Watertown City Council

Agenda Item:	Extra Work for 2019 Mill & Overlay Project
Request for Action:	Adopt Resolution #2019-72 - Authorization for Extra Work
Department:	Engineering

2019 MILL AND OVERLAY - ADDITIONAL WORK
 CITY OF WATERTOWN, MINNESOTA
 BMI PROJECT NO. C16.117754

2019 MILL & OVERLAY

ADDITIONAL ITEMS LEGEND

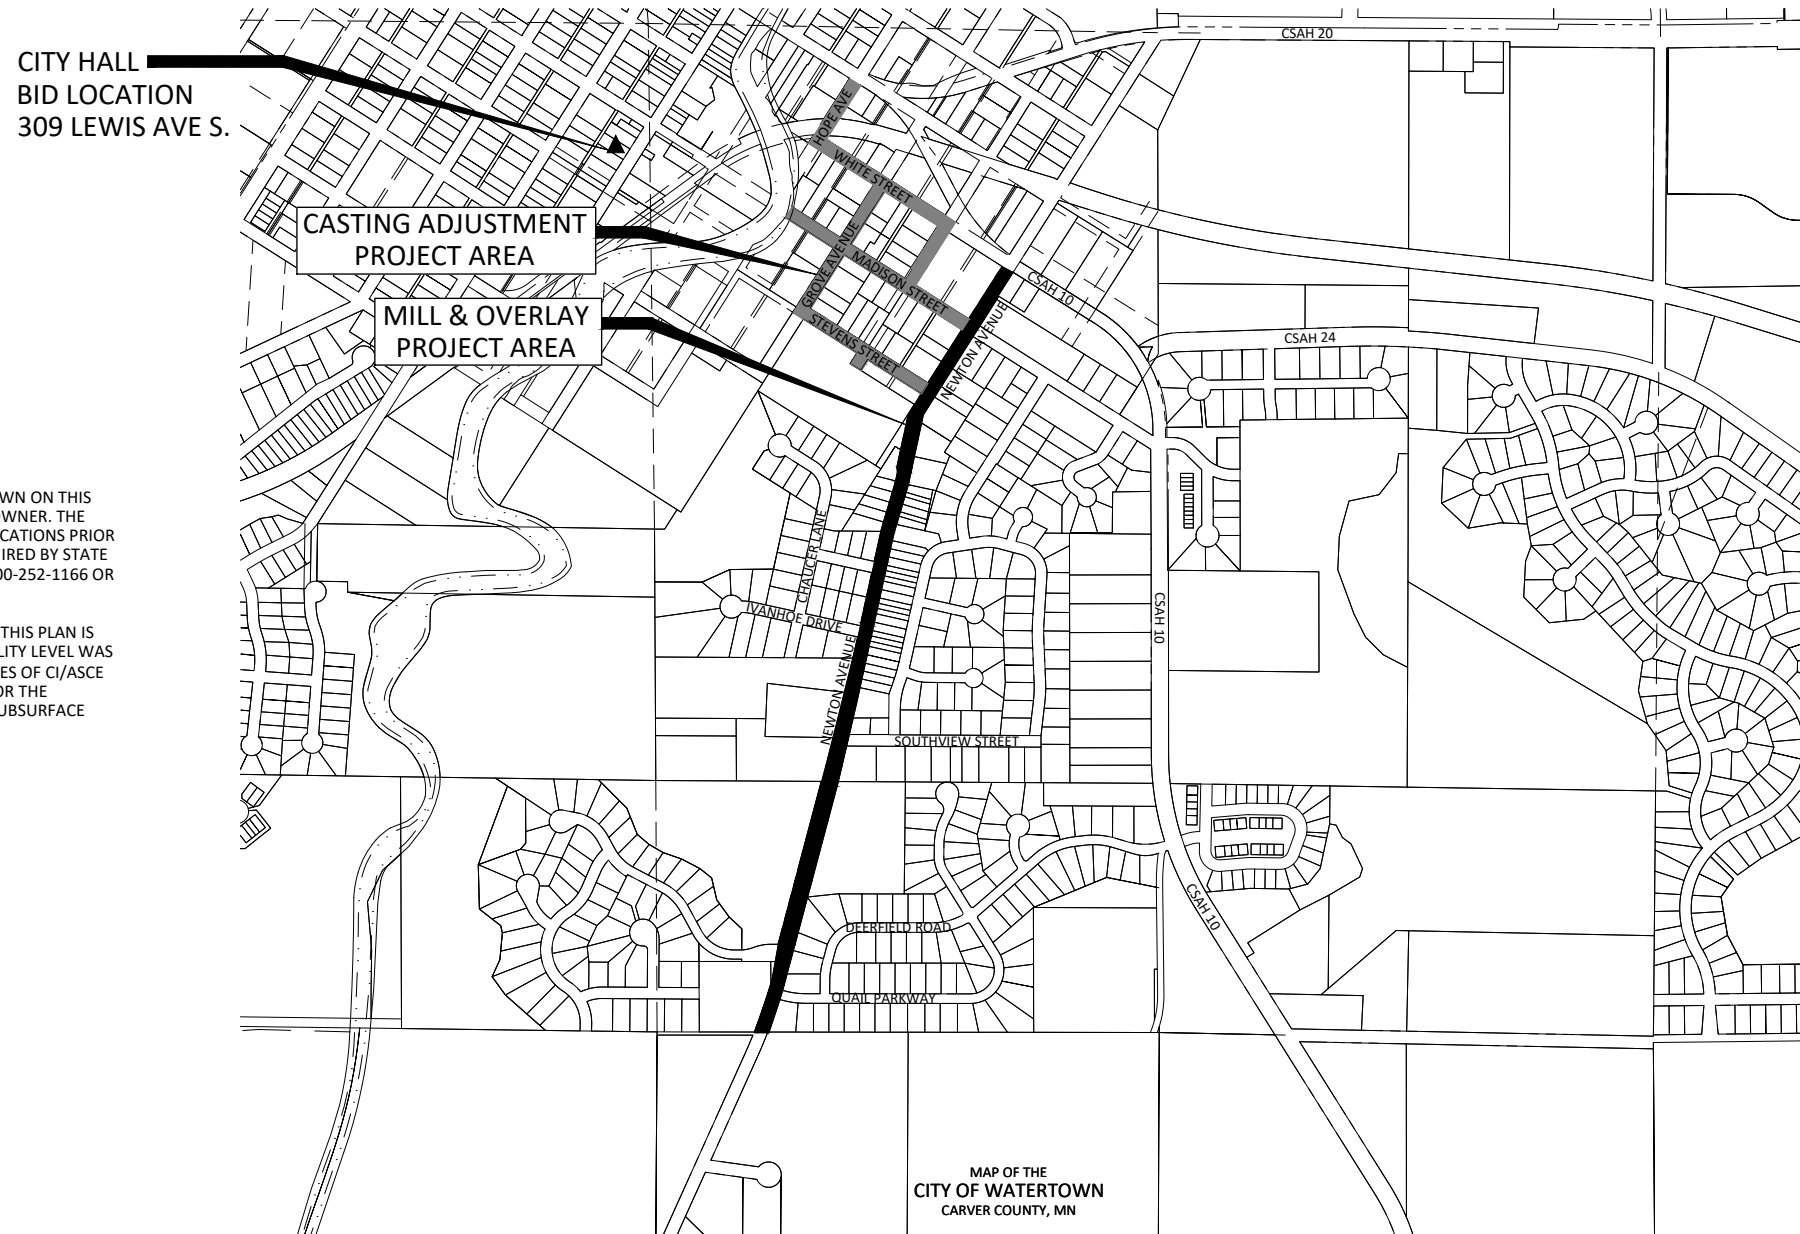
After award of the contract of the 2019 Mill & Overlay project to Omann Contracting, staff identified two areas where additional work could improve safety and function of the roadway and sidewalks along Newton Ave.

The first location was identified by Public Works and would pave the gravel area adjacent to the Newton Ave lift station. Currently this area stays muddy during wet conditions and tracks gravel onto the paved street as the area is utilized by Public Works staff on a daily basis to take pump readings from the lift station. The existing depth of gravel is unknown. If the existing gravel depth is too shallow, the entire area will be excavated and reconstructed to the City standard street section. Pricing to complete the full depth work by the contractor is \$4,440.00. If gravel is already determined to be deep enough, 4.5 inches of material would be removed from the surface and paved with 4.5 inches of bituminous, to match the City standard street section. Staff will work with the Contractor in the field during construction to determine if this is an option.

The second location would upgrade an existing pedestrian curb ramp to meet ADA standards at the corner of Madison Street and Newton Ave. This was not included in the original bidding documents. This work would include removing several panels of concrete sidewalk and curb, minor grading, constructing new curb, sidewalk, truncated domes, and turf restoration. Pricing to complete the ADA improvements by the Contractor is \$8,716.80.

SHEET
C6.03

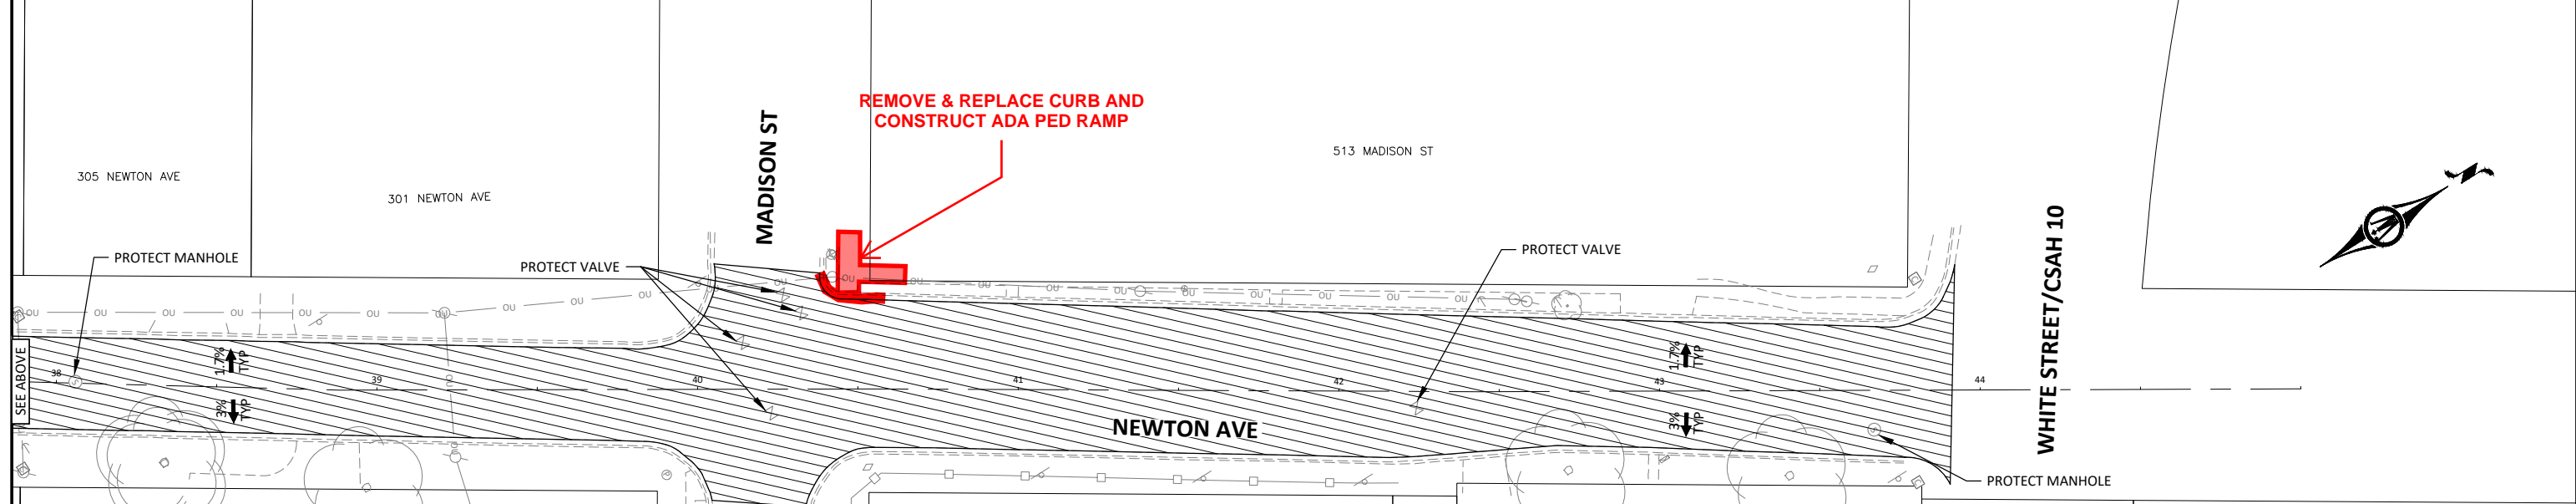
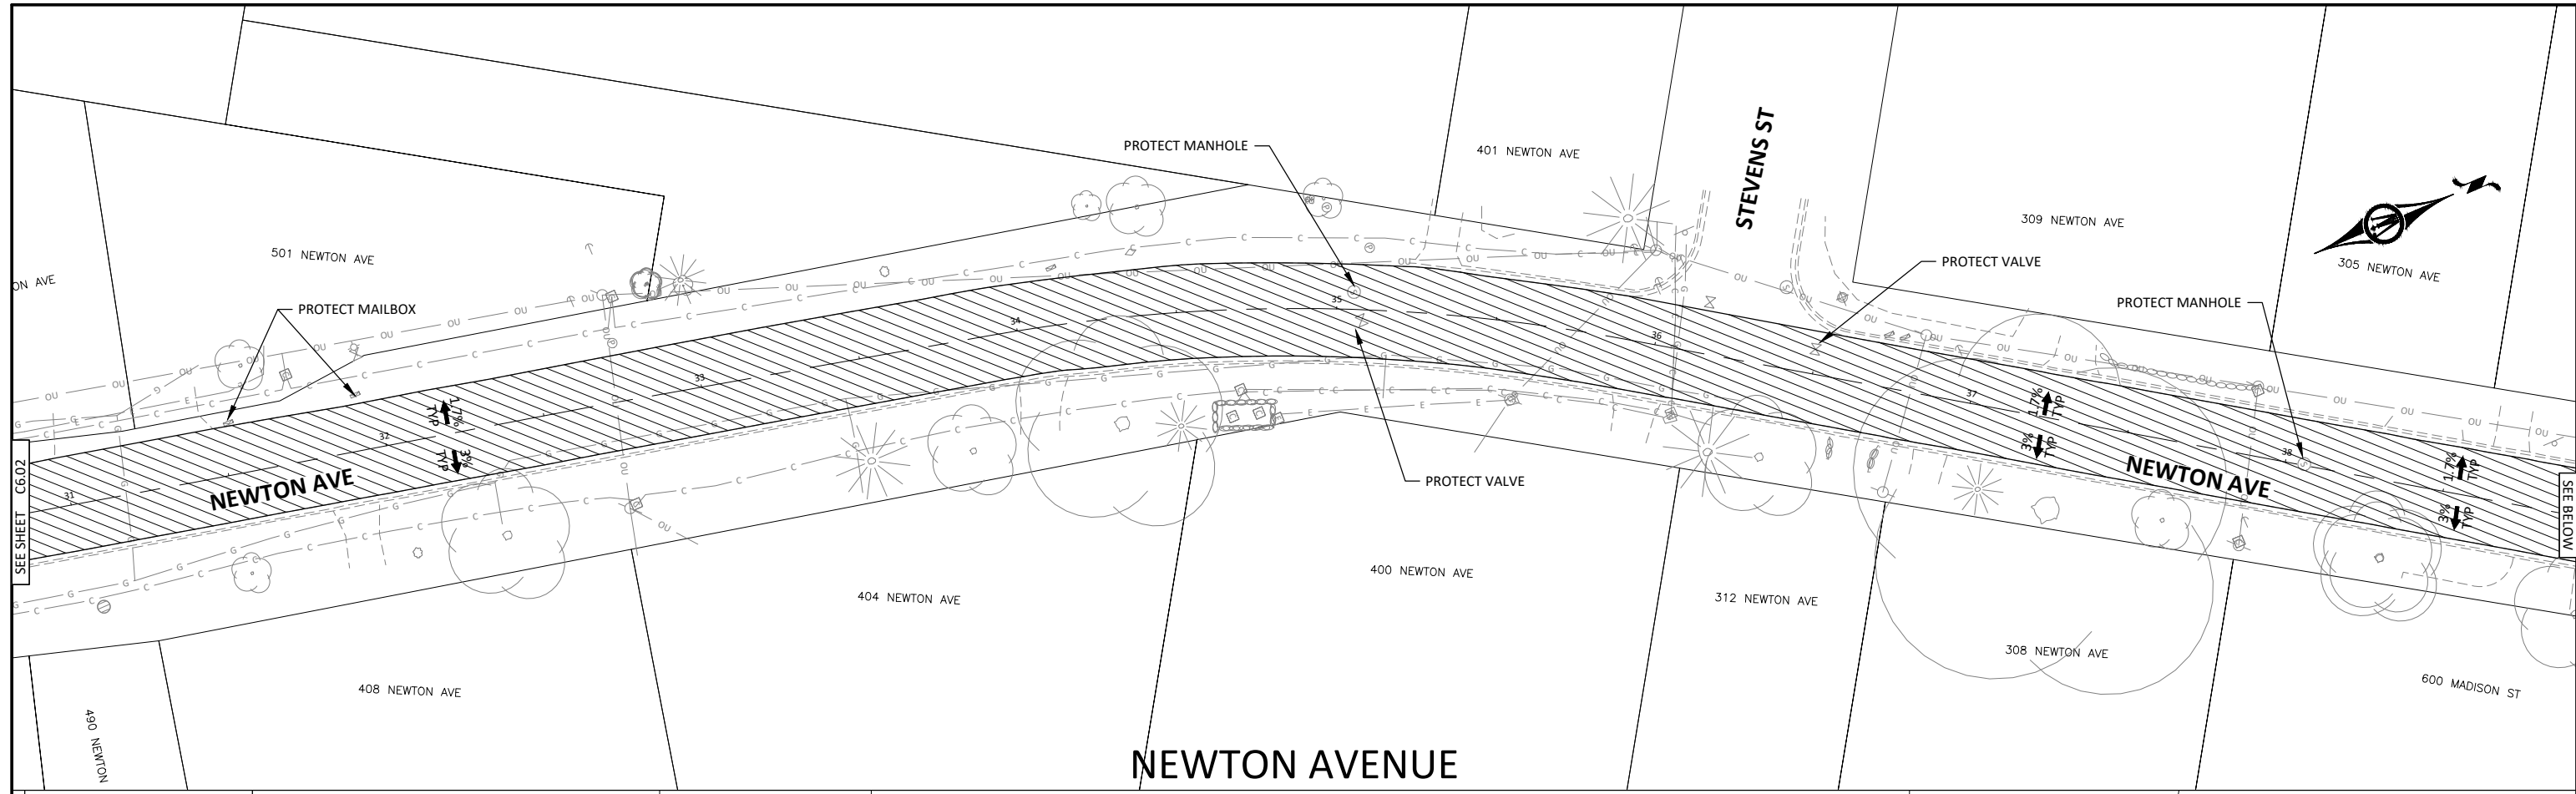
**REMOVE & REPLACE CURB AND
CONSTRUCT ADA PED RAMP**
